Re: Winterberry Reserve

On behalf of the City of Waukesha, we have reviewed the application documents dated 01/27/2025 submitted by Excel Engineering for Winterberry Reserve.

Veridian Homes is proposing a residential PUD and preliminary plat for the development of 79 homes. The intent of the PUD overlay would be to establish certain standards to allow more diverse and cost efficient owner-occupied housing types in accordance with the goals set forth in the City of Waukesha's Comprehensive plan and housing study.

**Storm Sewer Design**

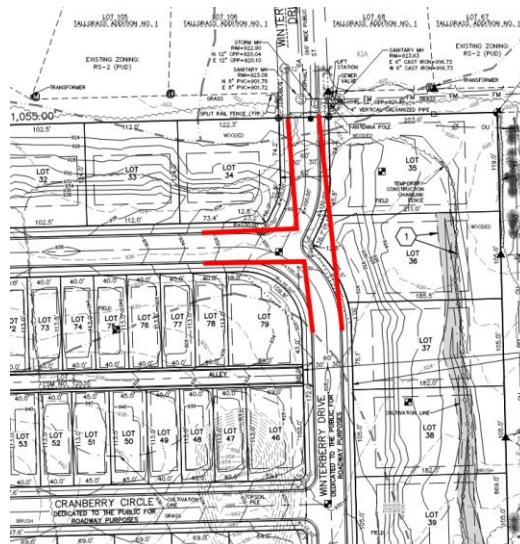
- 49. No calculations were included. Provide storm calcs including overland flow routing.
- 50. The site is somewhat rolling and there are high spots and low spots that won't necessarily encourage 100-yr flows to travel in the direction that storm sewers are routed.
- 51. Bypasses (at least 2 of which will go off-site without control (Windsor Place, Winterberry Drive) could cause problems for off-site drainage systems.
- 52. Accumulations at sag points (between lots 24 and 25 on the loop and opposite lot 1) may not safely collect 100-yr flows and/or safely overflow them to the proposed ponds.
